Project	IEEE 802.16 Broadband Wireless Access Working Group < http://ieee802.org/16 >	
Title	Proposed structure to harmonize the CMI and CSI timing in control channel	
Date Submitted	2006-09-17	
Source(s)	Wu Xuyong, Huawei Huawei Industrial Base, Bantian, Longgang, Shenzhen 518129 P.R.C	Voice: +86-755-28972327 Fax: wuxuyong@huawei.com
Re:	80216h-06_021: Third Working Group Review: P802.16h Working Document (2006-08-10)	
Abstract	We need to figure out a common frame structure for the CMI and CSI, so that it can be unified as a whole to form a so called control channel.	
Purpose	To consolidate the working document.	
Notice	This document has been prepared to assist IEEE 802.16. It is offered as a basis for discussion and is not binding on the contributing individual(s) or organization(s). The material in this document is subject to change in form and content after further study. The contributor(s) reserve(s) the right to add, amend or withdraw material contained herein.

Proposed structure to harmonize the CMI and CSI timing in control channel

Huawei Technologies Co., Ltd.

Figure hxx – Uplink and Downlink Control Channel Slots in the frame structure

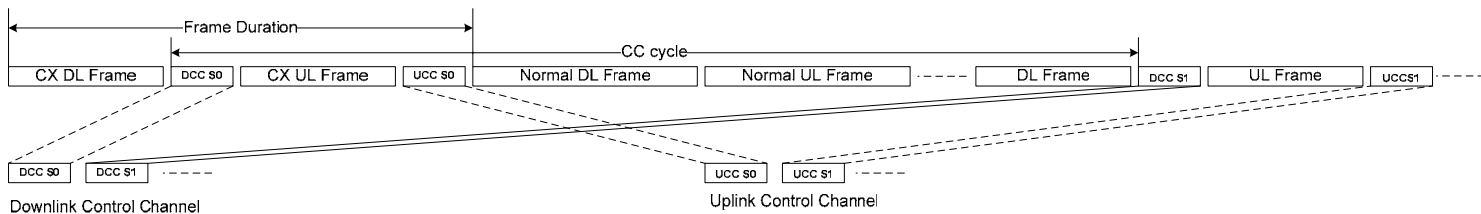
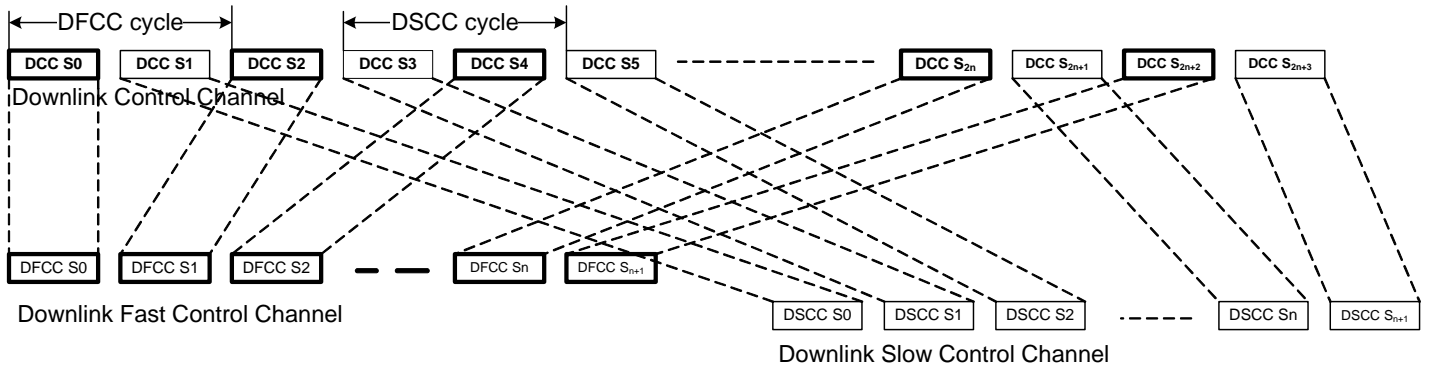
The figure below propose a even occupancy of the control channel slots to be used as FCC slots (old CMI) or SCC slots (old CSI).

The 1st and 2nd figure is proposed to substitute Figure h10 in current WD.

Figure hxx – Slots allocation for IDSCC and ODSCC

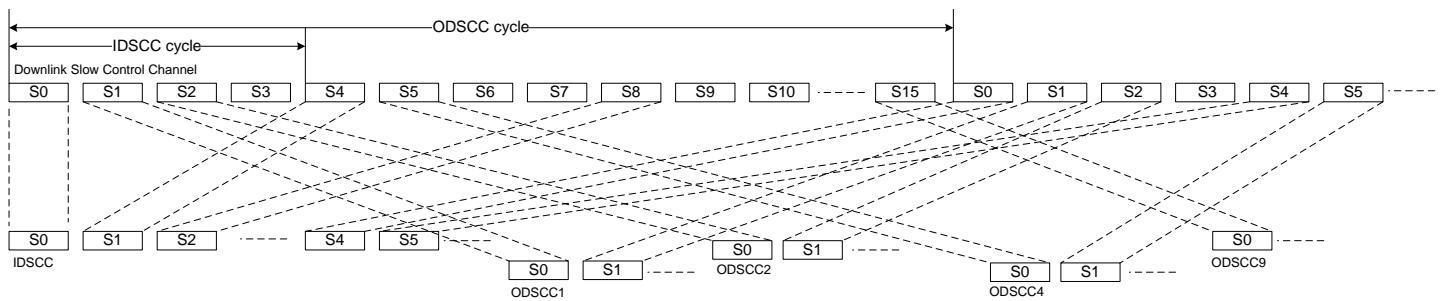
The 3rd figure is proposed to be included into 15.3.1.1.1 CSI scheduling.
